#eta1000455

Masterplan
33 Carrington Street
Adelaide SA 5000
Attention: Ms. Kirsten Falt

ADELAIDE CENTRAL PLAZA - PROPOSED REDEVELOPMENT RESPONSE TO REQUEST FOR FURTHER INFORMATION - TRAFFIC AND PARKING

**ADELAIDE CENTRAL PLAZA
REDEVELOPMENT
PROPOSED BICYCLE PARKING DIMENSIONS
CONCEPT PLAN**

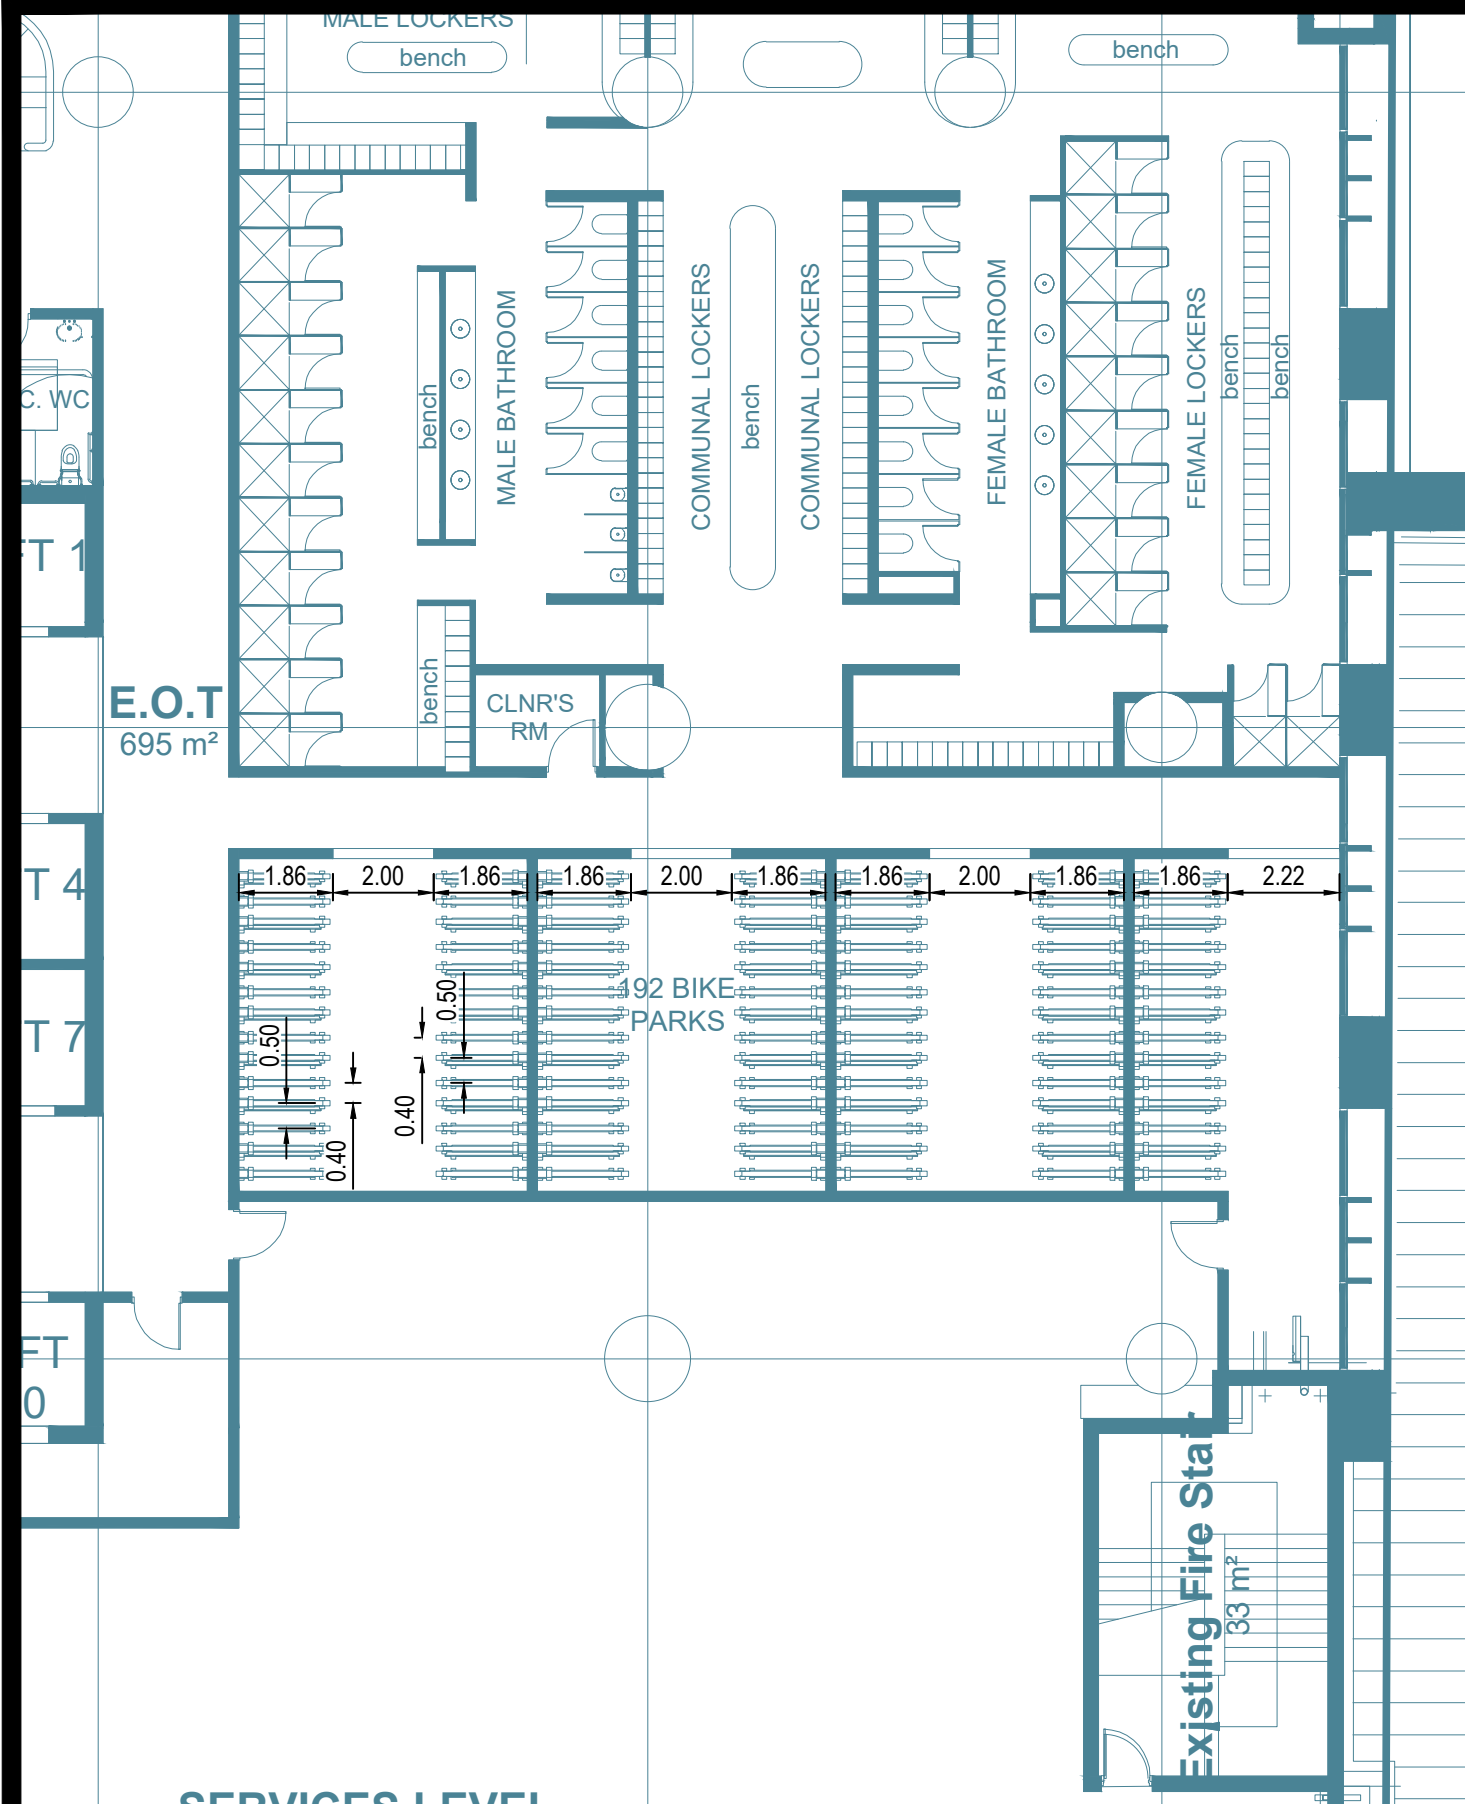
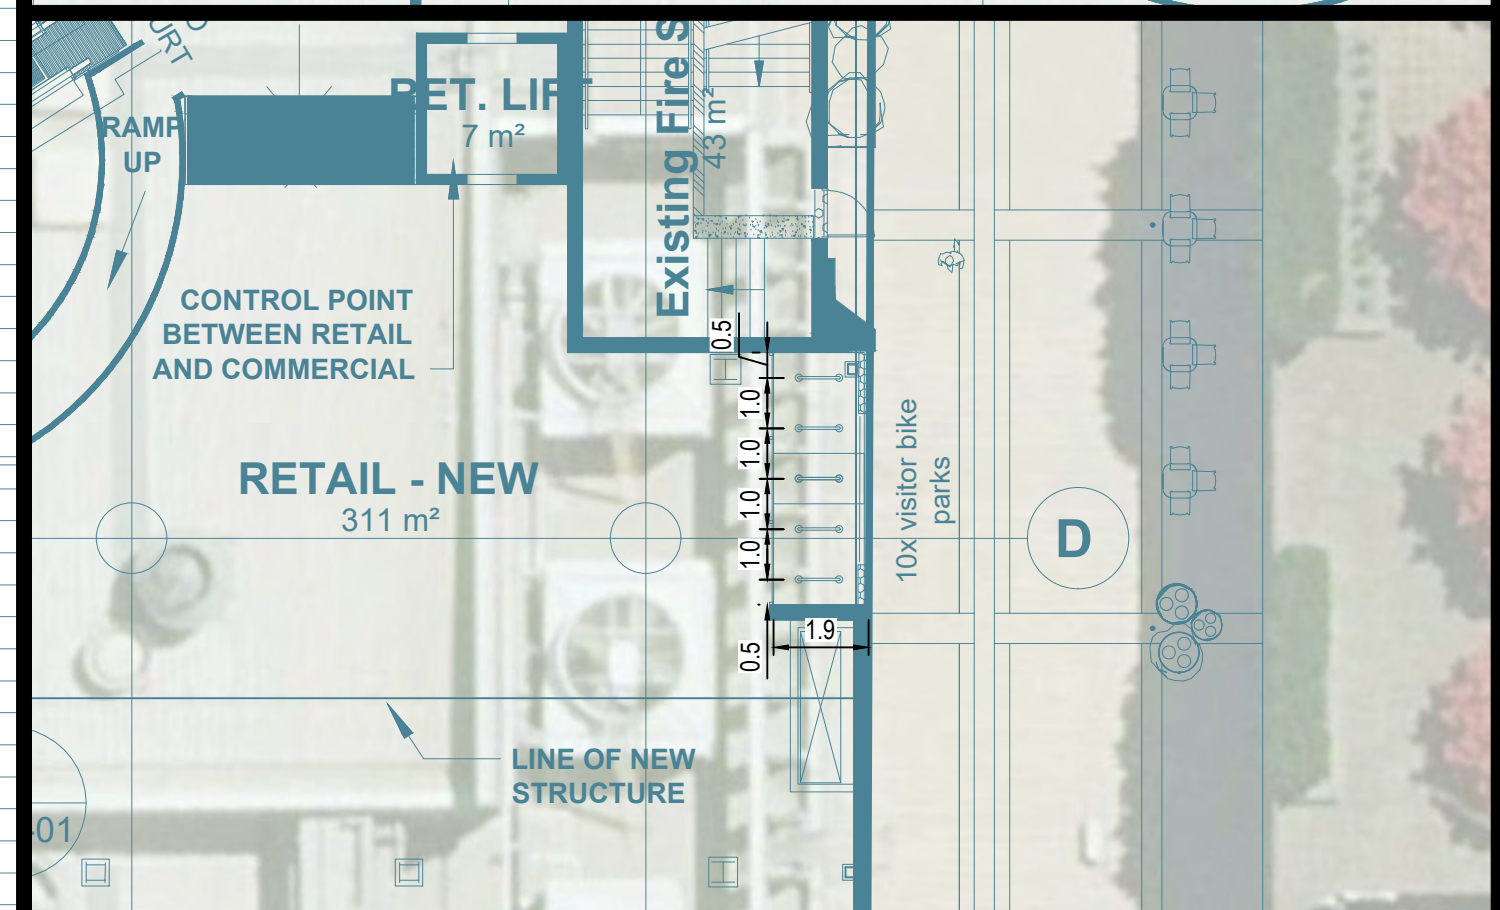
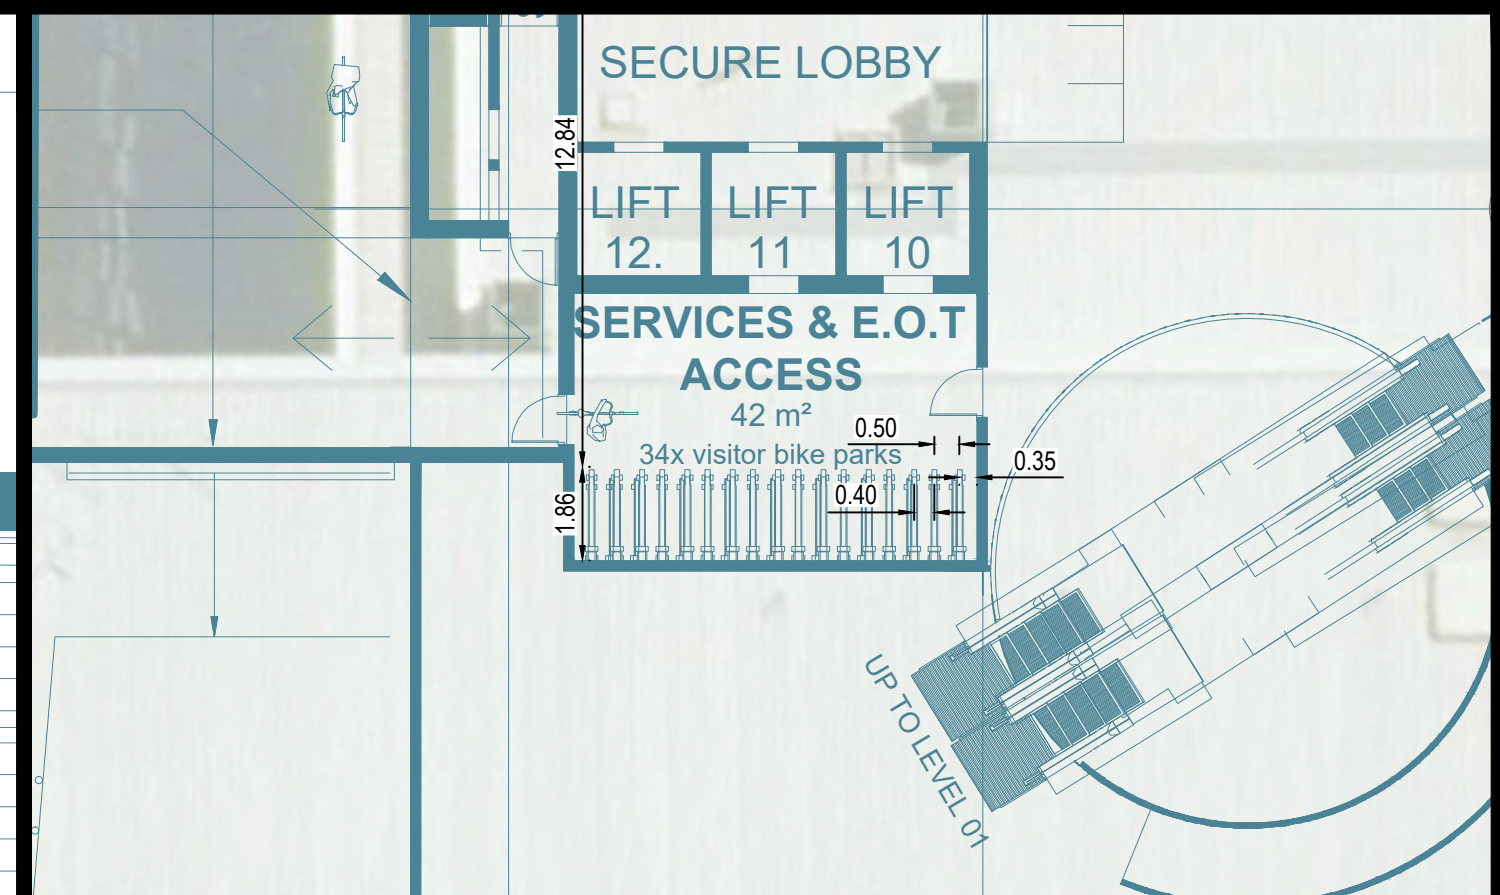
- Information is required demonstrating bicycle parking complies with AS2890.3 - Dimensions of bike parking, the proposed parking system and pathways to the facilities should be detailed.

The site proposes two types of bicycle parking systems, bicycle rails and a multi-tier racking system.

The 5 bicycle rails (10 parking spaces) are located with access to Charles Street and are provided in accordance with Figure B5 of AS2890.3:2015.

The multi-tier bicycle parking is proposed for both the EOT facilities on Level 4 and within the EOT lobby. It is understood that the proposed system is to be Cora Bike Rack Double Tier system. The proposed system provides a minimum 2.0m access aisle between parking areas/walls, which meets the aisle requirements of Figure B9 of AS2890.3:2015. The parking spaces are understood to be a 'Dynamic' parking system, which have separation of between 0.4m and 0.5m, which meets the requirements Clause 3.3(a) of AS2890.3:2015.

As such the proposed bicycle parking systems proposed meet the relevant Australian Standards.
